# HISTORIC AND DESIGN REVIEW COMMISSION

**HDRC CASE NO:** 2024-321  
**ADDRESS:** 329 W LULLWOOD AVE  
**LEGAL DESCRIPTION:** NCB 6537 BLK 17 LOT 7&8  
**ZONING:** R-5, H  
**CITY COUNCIL DIST.:** 1  
**DISTRICT:** Monte Vista Historic District  
**APPLICANT:** Jason Balderas/San Antonio Custom Steel  
**OWNER:** DOEBBLER CATHY  
**TYPE OF WORK:** Metal porch screening  
**APPLICATION RECEIVED:** September 09, 2024  
**60-DAY REVIEW:** November 8, 2024  
**CASE MANAGER:** Claudia Espinosa

The applicant is requesting a Certificate of Appropriateness for approval to enclose the existing porch with decorative wrought iron panels and door.

SIDE OF HOUSE  
WHERE PROPOSED  
ENCLOSURE TO BE  
INSTALLED.

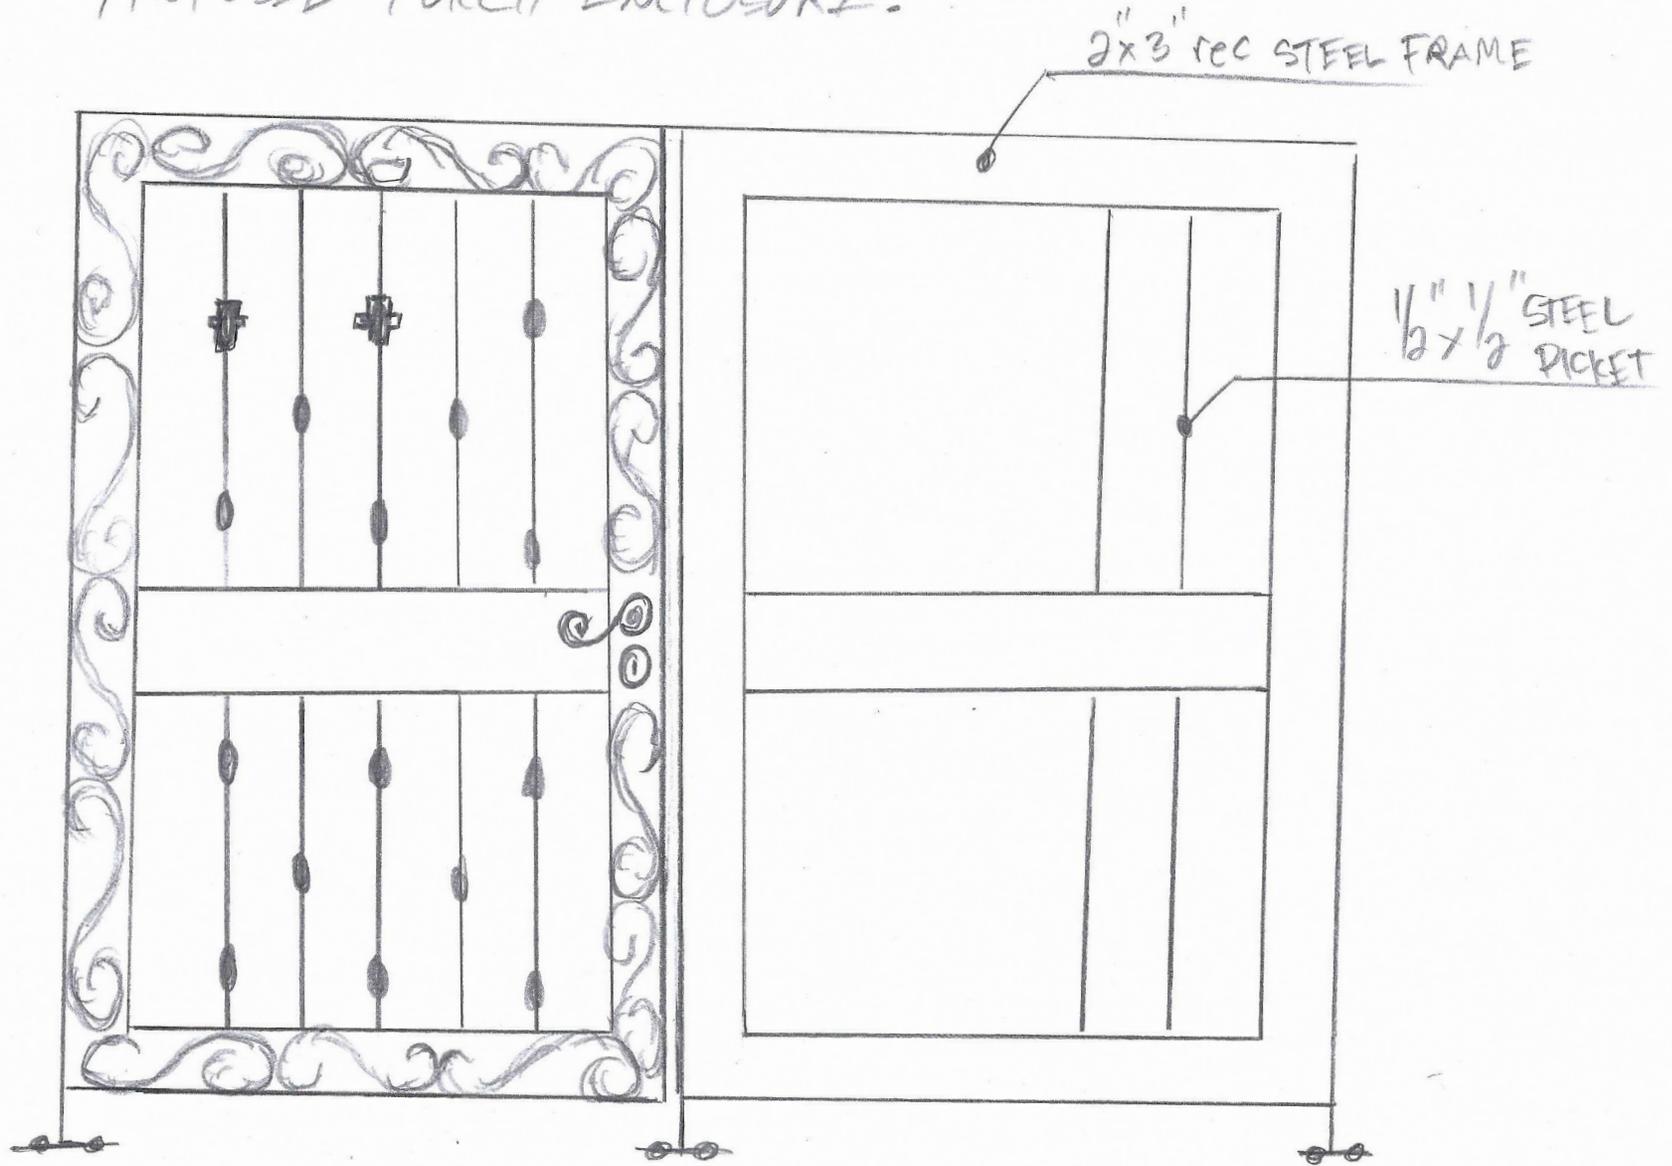
- a. The primary structure located at 329 W Lullwood Ave is a one-story, single-family home constructed c. 1929. The structure features a side-gable composition shingle roof, stucco siding, and historic one-over-one wood windows, and an asymmetrical front porch. This property contributes to the Monte Vista Historic District.
- b. PORCH (ENCLOSURE) – The applicant is requesting to install floor-to-ceiling wrought iron panels to the front porch. The Guidelines for Exterior Maintenance and Alterations 7.B. ii, state to refrain from enclosing side and rear porches, particularly when connected to the main porch or balcony. Original architectural details should not

be obscured by any screening or enclosure materials. Alterations to side and rear porches should result in a space that functions, and is visually interpreted as, a porch. This request is not consistent with the guidelines.

Staff does not recommend approval of the enclosure of porch based on finding b.
